# Access Compliance Report

## Public Rights-of-Way

### (Curb Ramps)

Intersection ID: 44418	Main Street: TRAVIS_GULCH_DR	Cross Street: ARDREY_KELL_RD	Location: SW
ADA ID: 515EC1317AAA	Ramp Type: Perp	Initial Pass/Fail: Fail	Overall Compliance: No
		Severity Score: 25

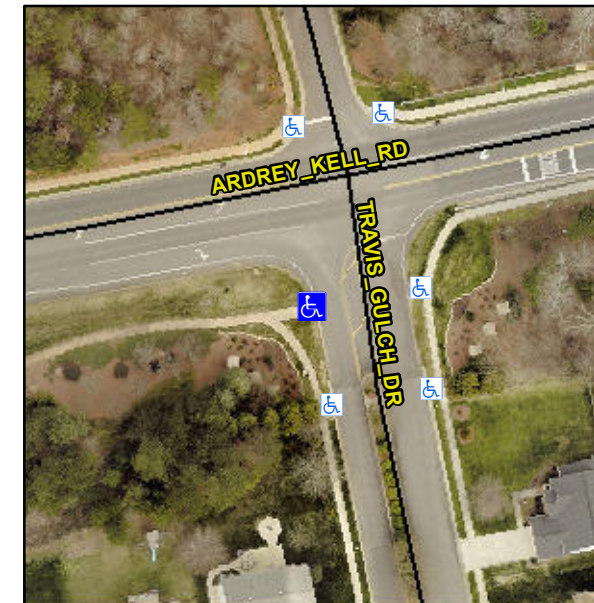
**R304.2.2, R304.5.3**

Compliance	Description	Data	Compliance	Description	Data
N/A	Ramp Length (in)	174.0	No	Ramp Slope (%)	10.1
Yes	Ramp Width (in)	72.0	No	Ramp XSlope (%)	6.0
N/A	Flare Type LT	N/A	N/A	Flare Type RT	N/A
N/A	Flare Slope LT (%)	N/A	N/A	Flare Slope RT (%)	N/A
N/A	Flare Traversable LT?	N/A	N/A	Flare Traversable RT?	N/A
N/A	Landing Length (in)	N/A	N/A	DWS Provided?	N/A
N/A	Landing Width (in)	N/A	N/A	DWS Contrast?	N/A
N/A	Landing Slope (%)	N/A	N/A	DWS Length (in)	N/A
N/A	Landing X Slope (%)	N/A	N/A	DWS Full Width?	N/A
N/A	Landing Curb? (Y/N)	N/A	N/A	DWS Offset (in)	N/A
N/A	Shared Landing?	N/A			
N/A	Gutter Ponding?	N/A	N/A	Gutter Slope (%)	N/A
N/A	Gutter Lip Ht (in)	N/A	N/A	Gutter X Slope (%)	N/A
N/A	Painted X Walk1?	No	N/A	Painted X Walk2?	N/A
	X Walk 1 Direction	To E		X Walk 2 Direction	N/A
N/A	X Walk 1 Width (in)	N/A	N/A	X Walk 2 Width (in)	N/A
	X Walk 1 Slope (%)	0.3		X Walk 2 Slope (%)	N/A
	X Walk 1 X Slope (%)	6.8		X Walk 2 X Slope (%)	N/A

**Remove & Replace Entire Ramp.**
